Hi-Fi Products Service Bulletin

Model: TC-WR445 No. **421**

Subject: Mechanical noise in play mode Date: December 27, 1994

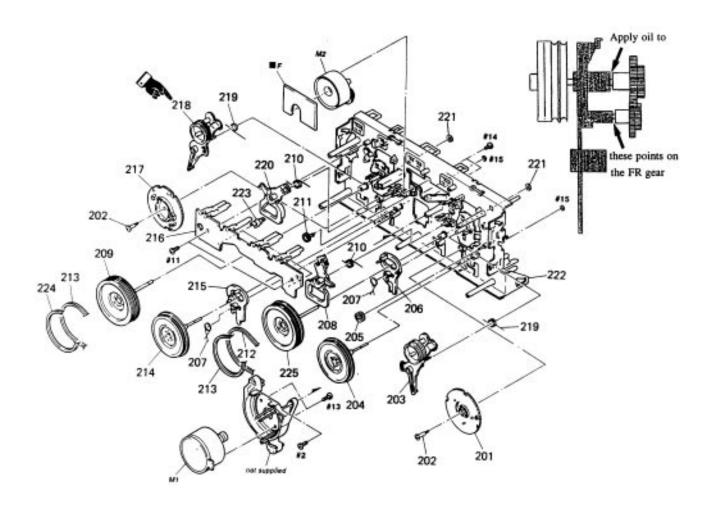
(64) A loud mechanical noise may be heard while in the play mode. This is due to a lack

of oil on the FR gear.

Solution: Apply a few drops of Sony oil, P/N 7-661-018-18, to the shaft of the FR gear. See

diagram below.
